# PLAN COMMISSION STAFF REPORT

JULY 2, 2015

## AETNA RETAIL

7201 191<sup>st</sup> Street

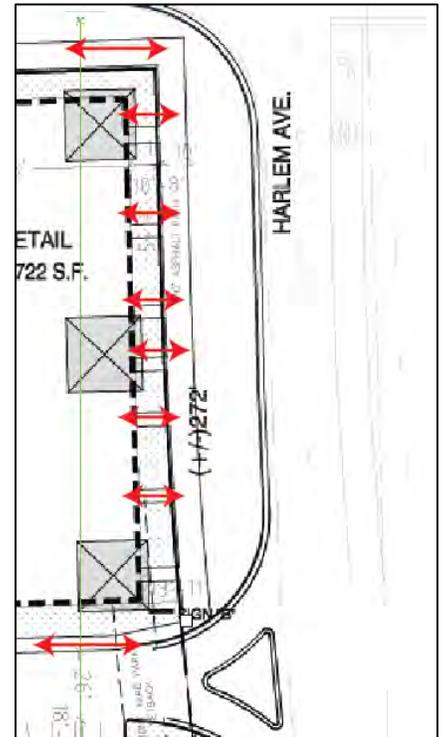
***Open Item #3: Cross -access easement will need to be platted to west and south properties.***

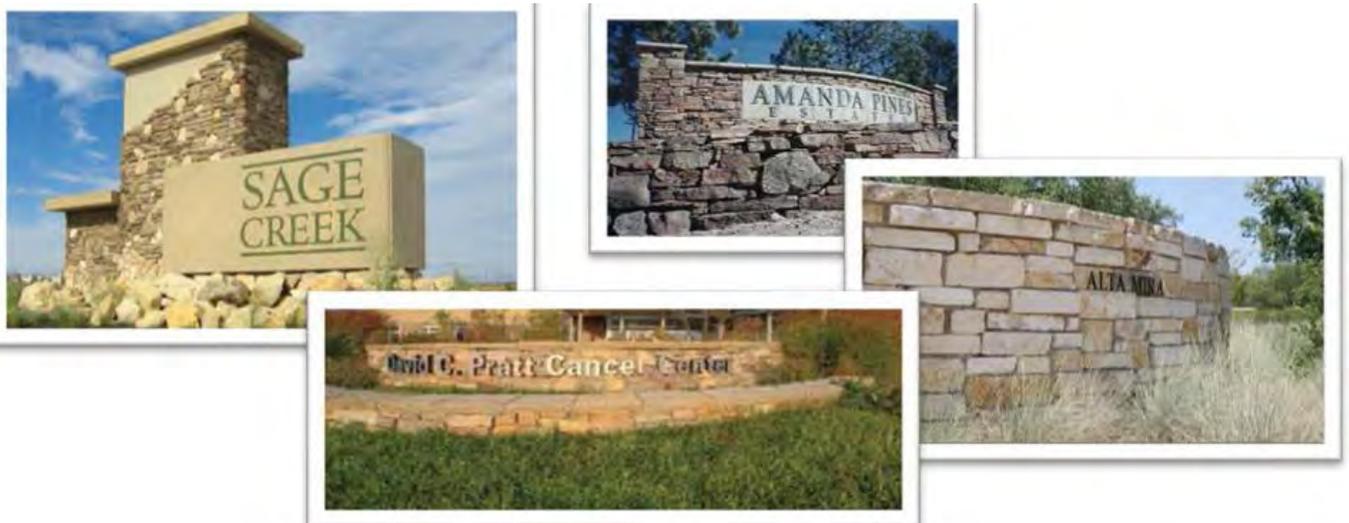
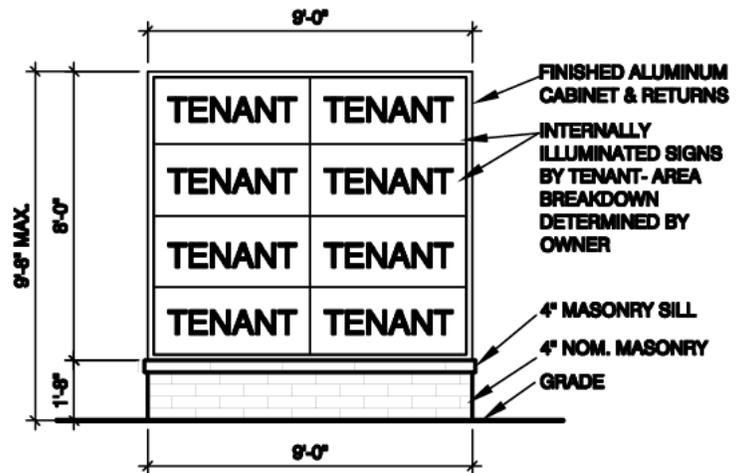
***Open Item #5: Minor landscape design and plant choice issues need to be addressed; location of street trees needs to be determined and conflict between cross access easement and trees must be resolved.***

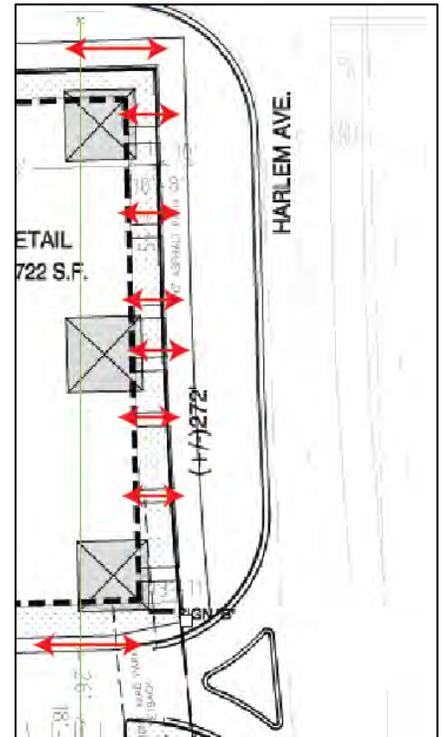
***Open Item #3: Cross -access easement will need to be platted to west and south properties.***

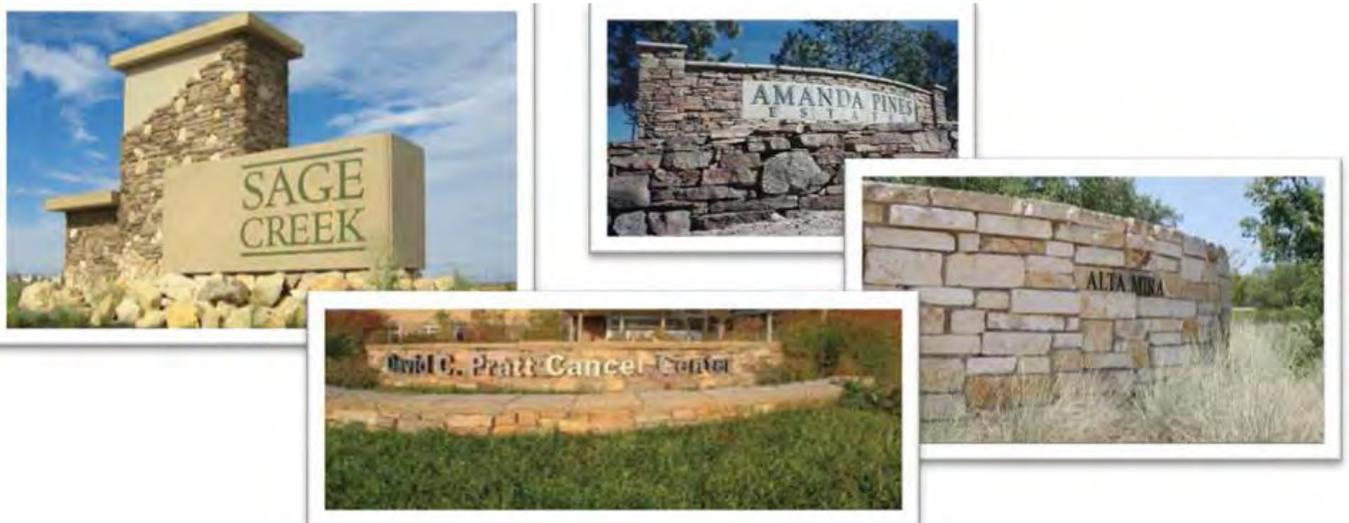
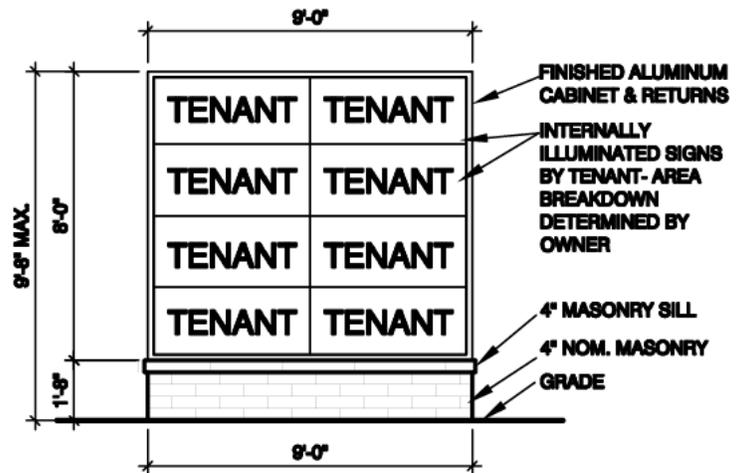
***Open Item #5: Minor landscape design and plant choice issues need to be addressed; location of street trees needs to be determined and conflict between cross access easement and trees must be resolved.***

### LIGHTING

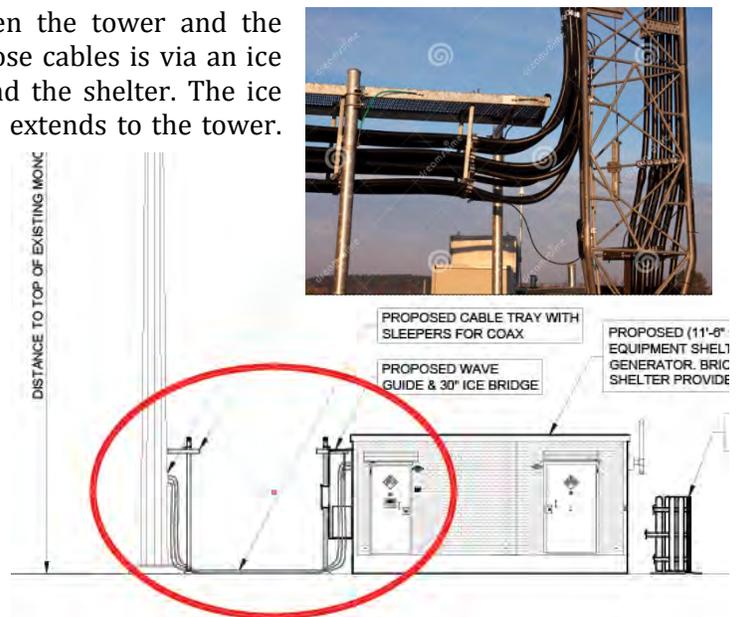
There are three (3) wall mount lights proposed on the shelter. Two (2) are on the south façade and one (1) on the north façade. Neither of these façades directly face residential property. The light is designed to shed light in a downward direction and is operated by a photocell. No photometrics have been provided, however the fence will provide some screening of the light fixture. The light is proposed to be mounted at a height of approximately 9' from the ground elevation. Staff recommends the light fixture be mounted on the structure at a height of 6' or less. PICTURE

**Open Item #5:** *Provide Photometrics or install the wall mounted light at an height lower than the adjacent fence.*
